RE: **1-ZN-2023 and 1-GP-2023**
6C692 (Key Code) and 98T77 (Keycode)
Pinnacle Peak Doggy Daycare

Planning & Development Services has completed review of the above referenced development application. The following comments represent issues or deficiencies identified by the review team and are intended to provide you with guidance for compliance with city codes, policies, and guidelines.

PRELIMINARY Basis of Design Report	
<input type="checkbox"/> ACCEPTED	
<input type="checkbox"/> ACCEPTED AS NOTED	
<input checked="" type="checkbox"/> REVISE AND RESUBMIT	
<small>Disclaimer: If accepted, the preliminary approval is granted under the condition that a final basis of design report will also be submitted for city review and approval (typically during the DR or PP case). The final report shall incorporate further water or sewer design and analysis requirements as defined in the city design standards and policy manual and address those items noted in the preliminary review comments (both separate and included herein). The final report shall be submitted and approved prior to the plan review submission. For questions or clarifications contact the Water Resources Planning and Engineering D

CONCEPTUAL GRADING & DRAINAGE AND UTILITY PLAN

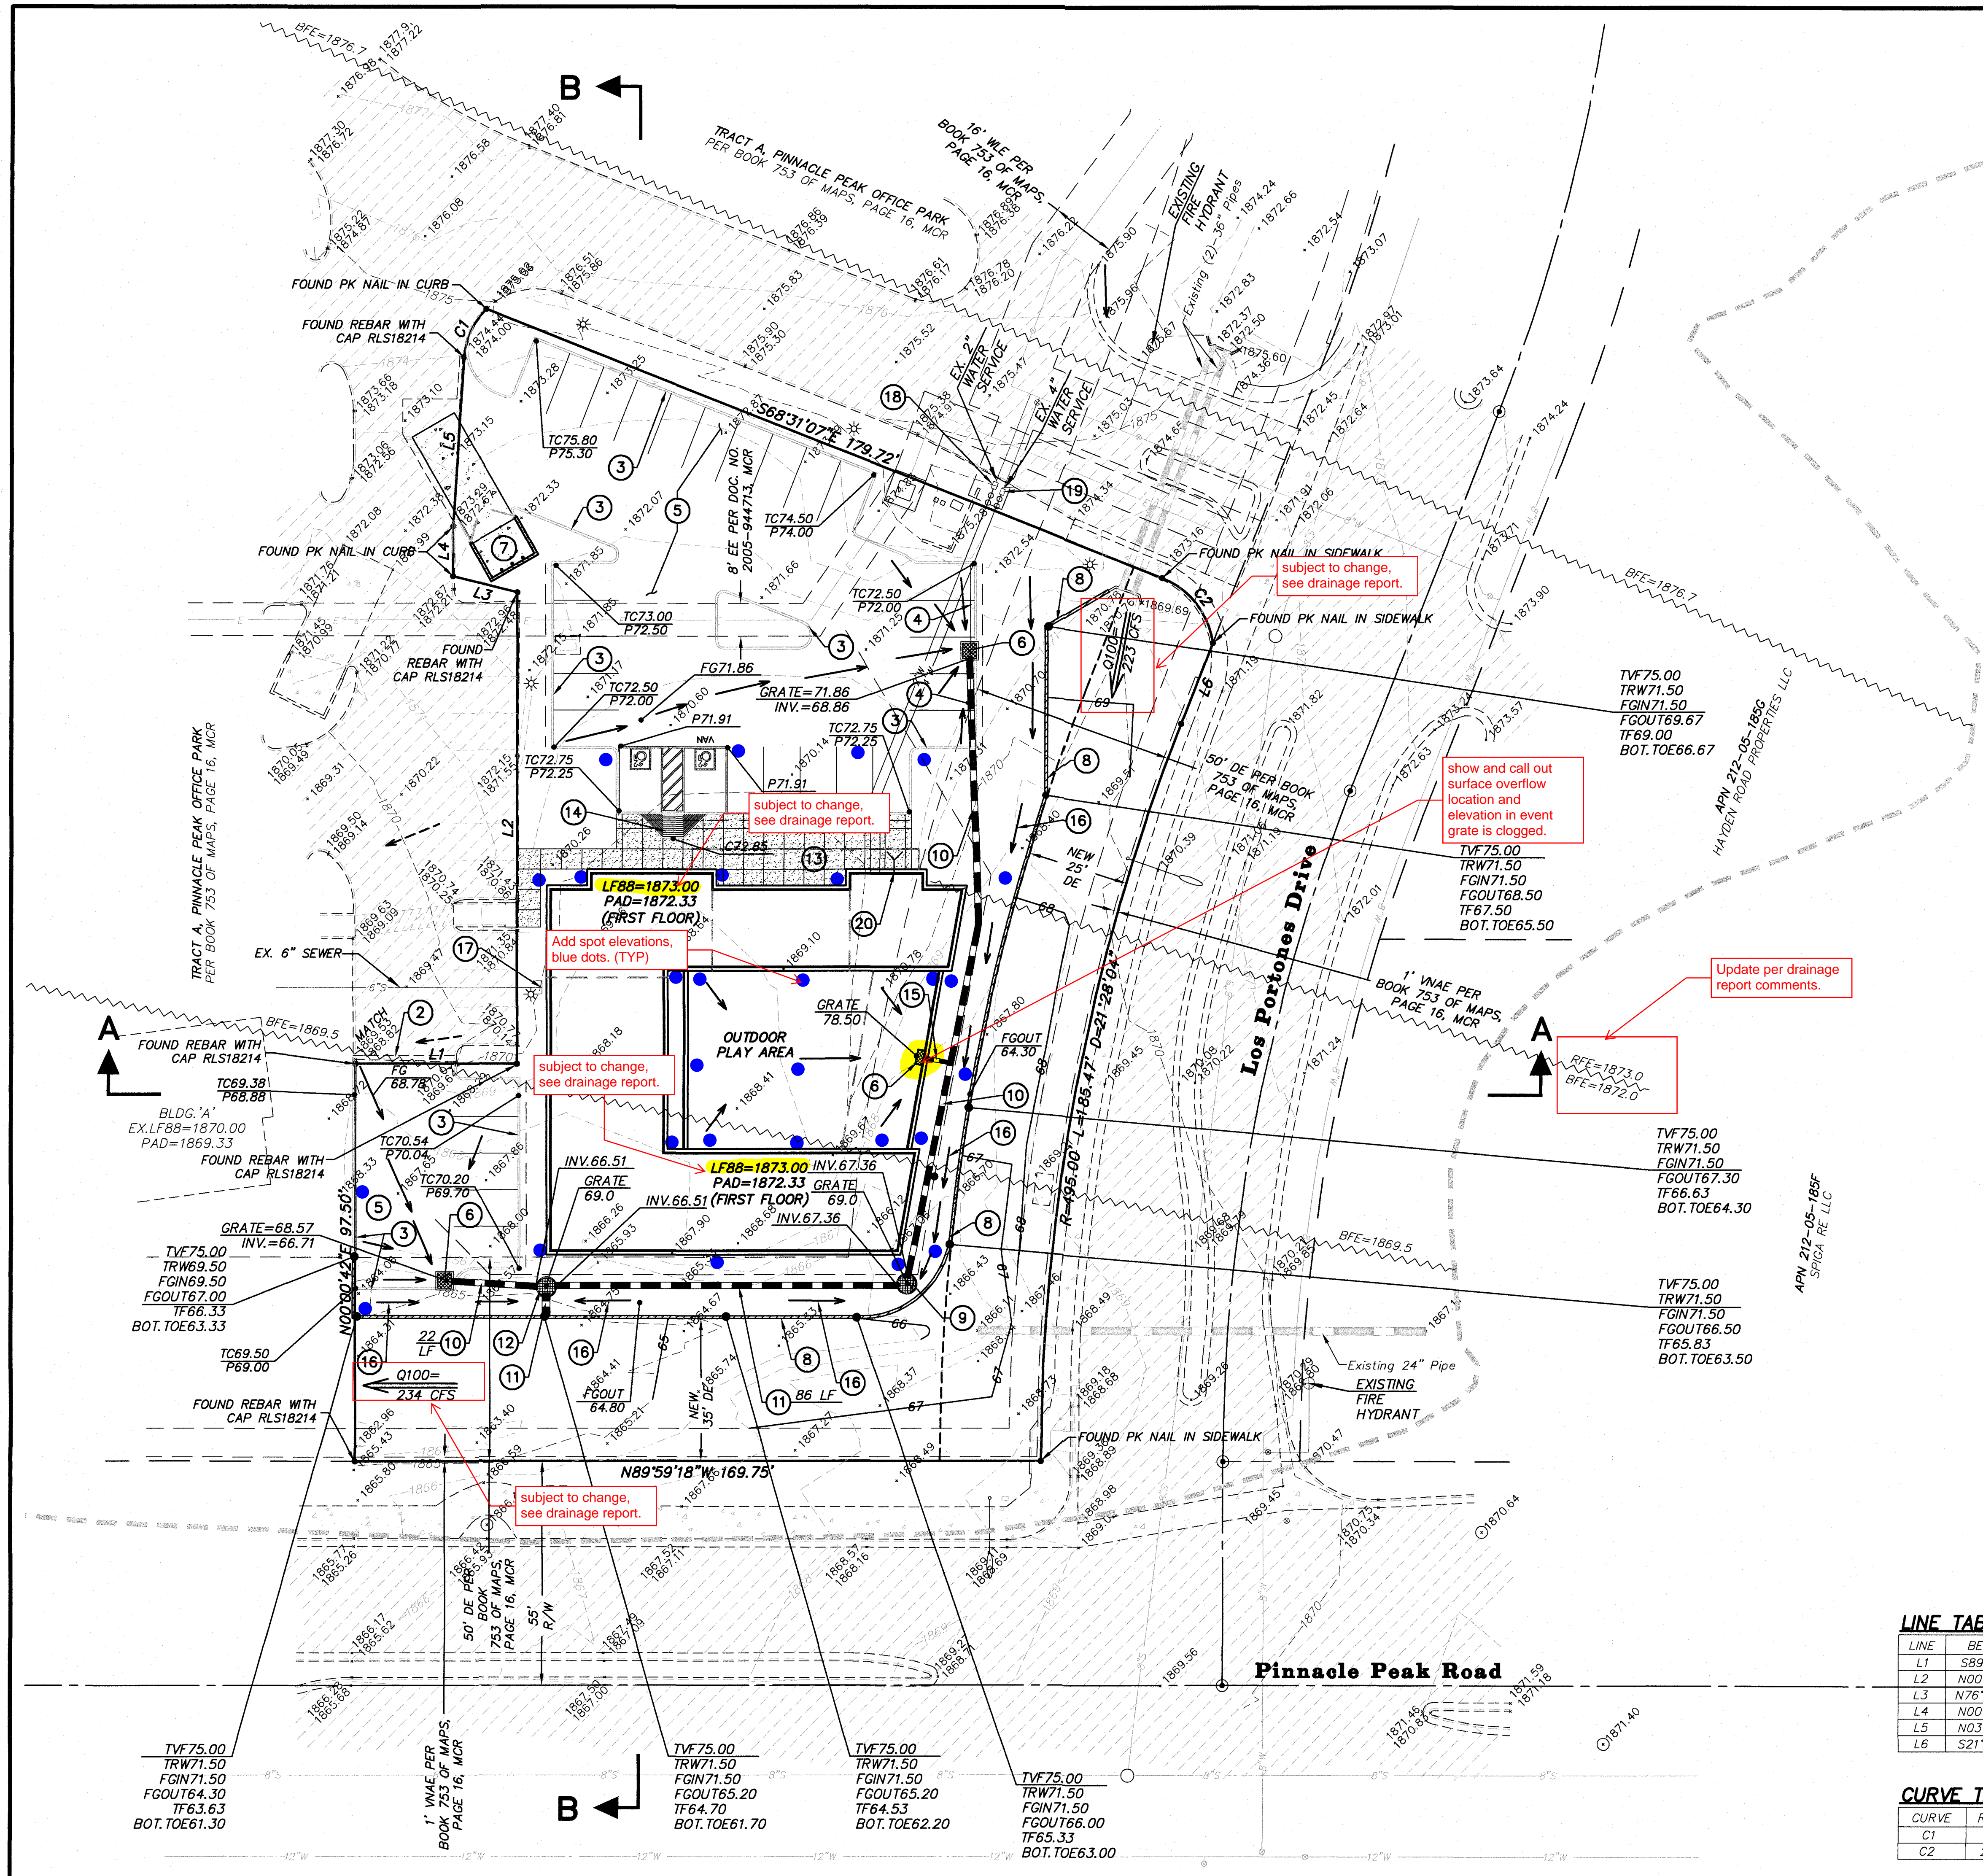
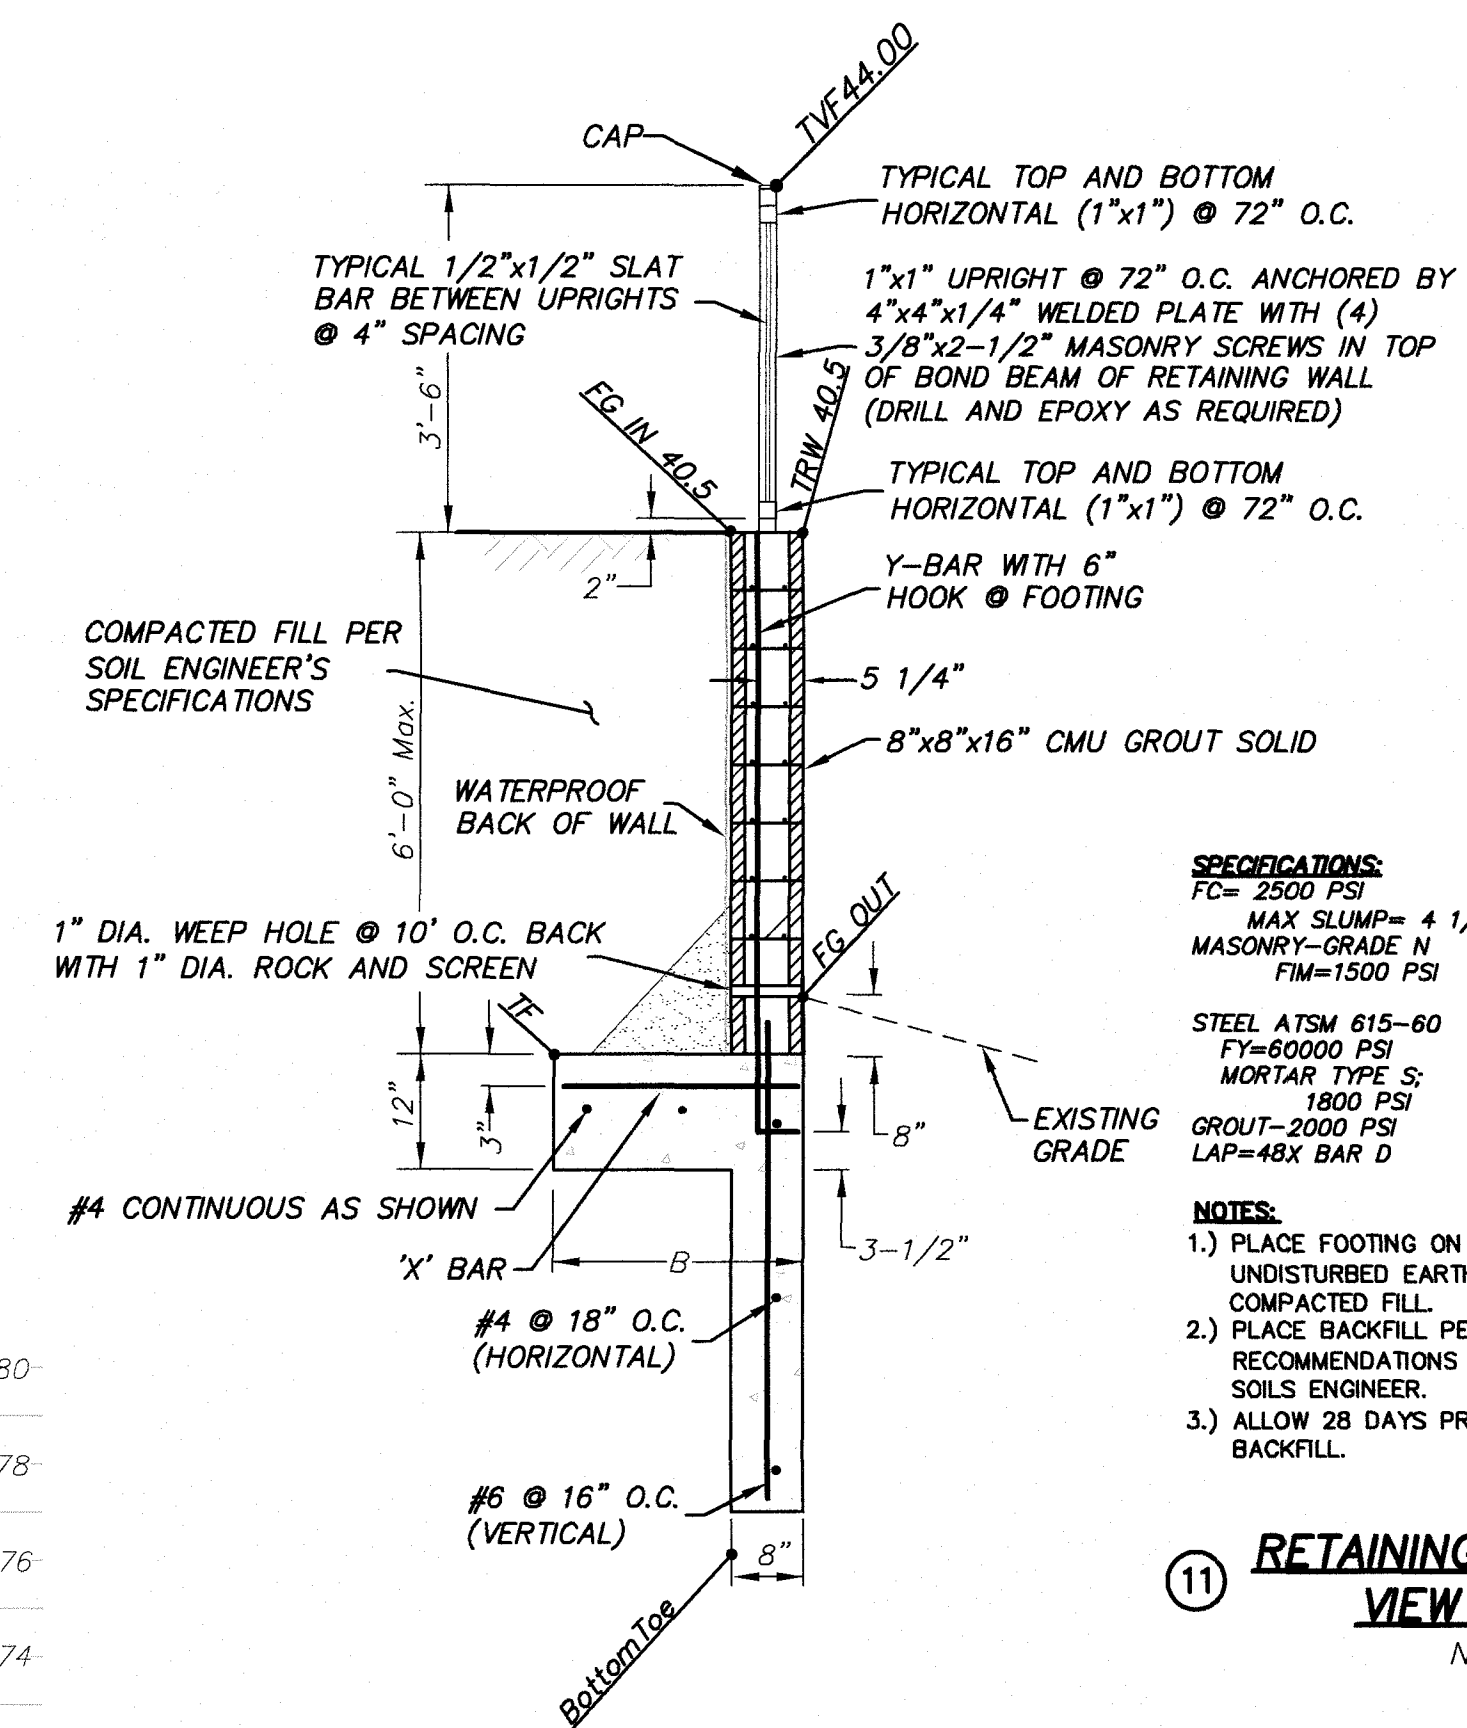
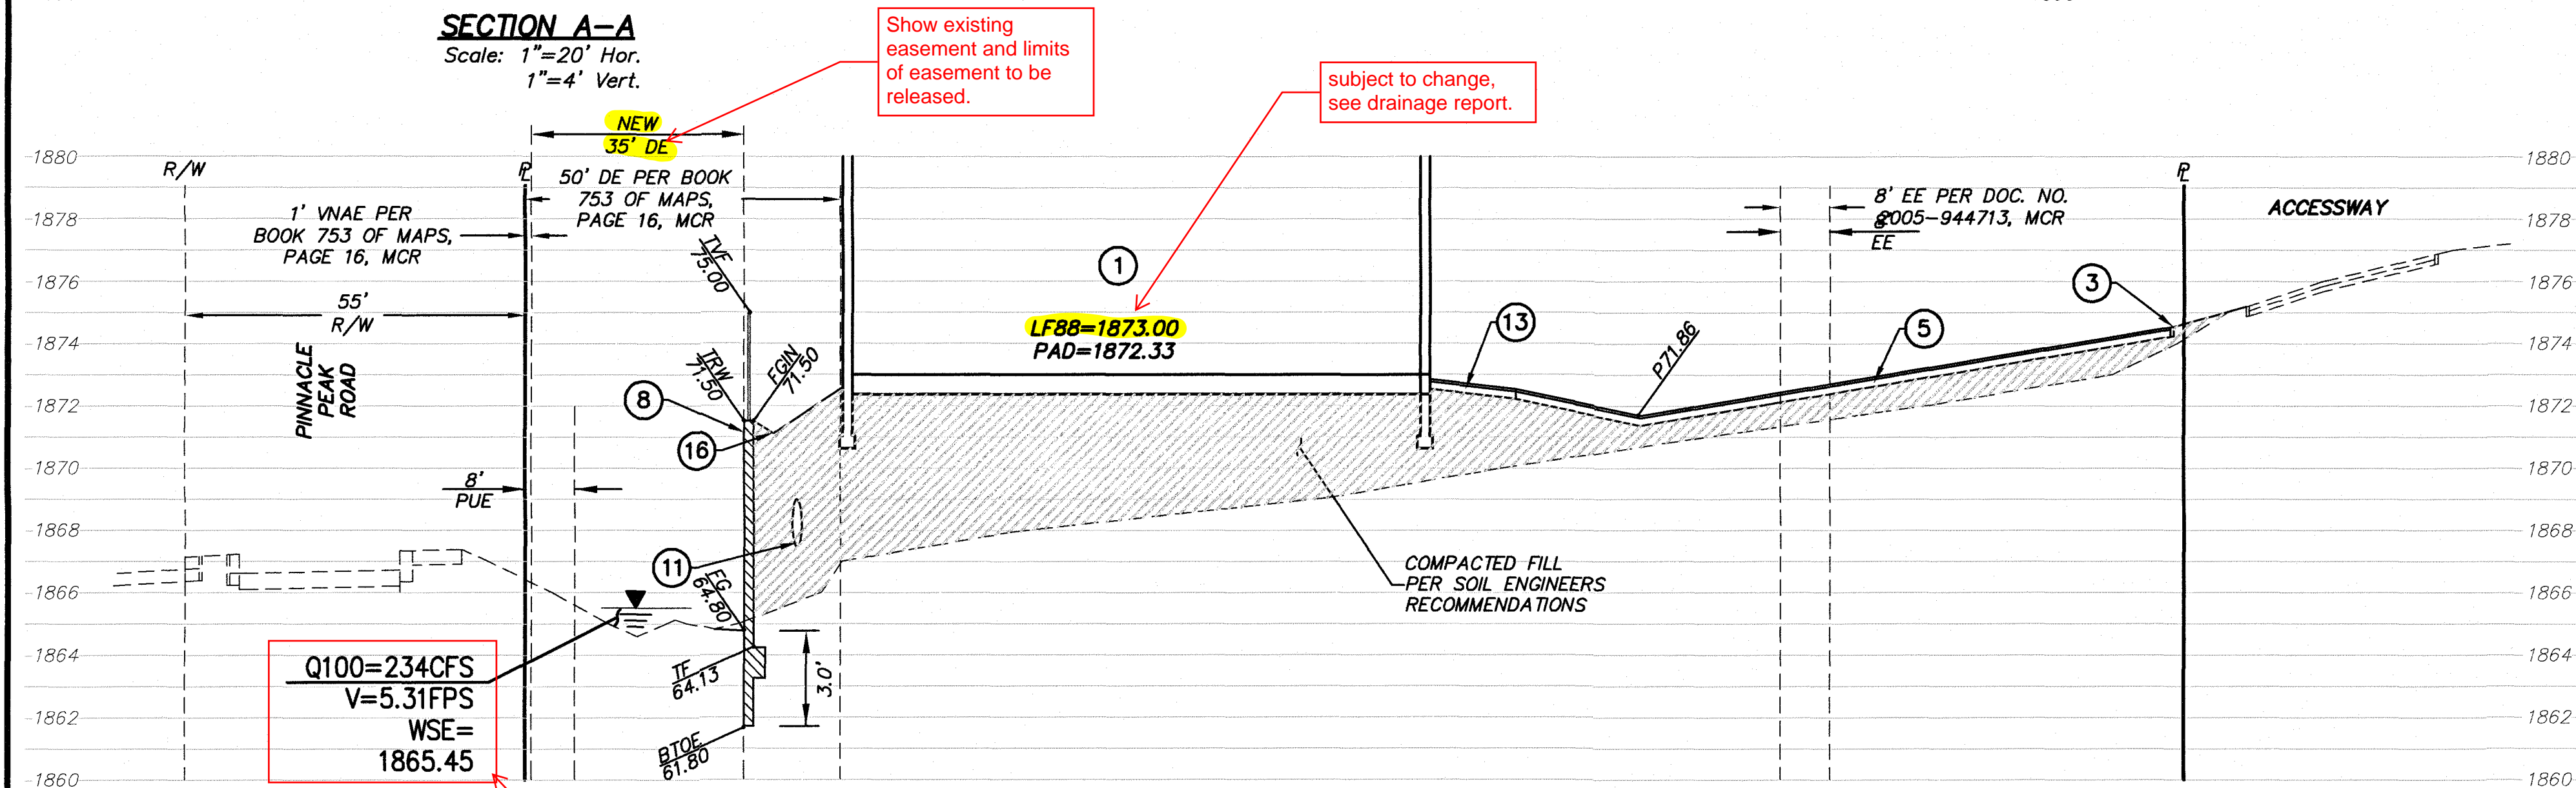
Add:
LFF =
BFE FEMA =
BFE Existing Conditions =
RFE =
